Access Compliance Report

Public Rights-of-Way

(Curb Ramps)

Intersection ID: 48463	Main Street: PANGLEMONT_DR	Cross Street: CHANDLER_HAVEN_DR	Location: S
ADA ID: CCA6E1F771EE	Ramp Type: PerpDiag	Initial Pass/Fail: Fail	Overall Compliance: No
Severity Score: 22.5			
Codes/Mitigation Info/Possible Solution		Field Measurements/Component Compliance

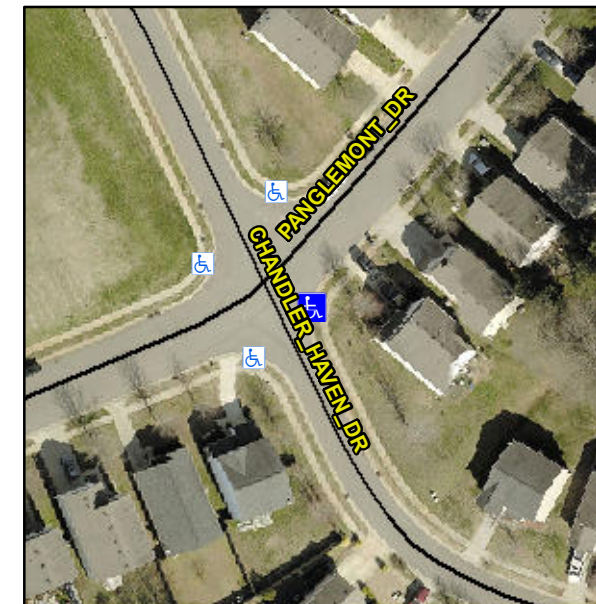
Not Found, R304.5.1, R304.2.2, R304.5.3

Compliance	Description	Data	Compliance	Description	Data
N/A	Ramp Length (in)	48.0	No	Ramp Slope (%)	11.9
No	Ramp Width (in)	47.0	No	Ramp XSlope (%)	2.5
N/A	Flare Type LT	N/A	N/A	Flare Type RT	N/A
N/A	Flare Slope LT (%)	N/A	N/A	Flare Slope RT (%)	N/A
N/A	Flare Traversable LT?	N/A	N/A	Flare Traversable RT?	N/A
N/A	Landing Length (in)	N/A	N/A	DWS Provided?	N/A
N/A	Landing Width (in)	N/A	N/A	DWS Contrast?	N/A
N/A	Landing Slope (%)	N/A	N/A	DWS Length (in)	N/A
N/A	Landing X Slope (%)	N/A	N/A	DWS Full Width?	N/A
N/A	Landing Curb? (Y/N)	N/A	N/A	DWS Offset (in)	N/A
N/A	Shared Landing?	N/A			
N/A	Gutter Ponding?	N/A	N/A	Gutter Slope (%)	N/A
N/A	Gutter Lip Ht (in)	N/A	N/A	Gutter X Slope (%)	N/A
N/A	Painted X Walk1?	No	N/A	Painted X Walk2?	No
	X Walk 1 Direction	To N		X Walk 2 Direction	To SW
N/A	X Walk 1 Width (in)	N/A	N/A	X Walk 2 Width (in)	N/A
	X Walk 1 Slope (%)	4.6		X Walk 2 Slope (%)	0.3
	X Walk 1 X Slope (%)	1.6		X Walk 2 X Slope (%)	4.8

Remove & Replace Curb Ramp With Two New Directional Ramps or Equivalent.
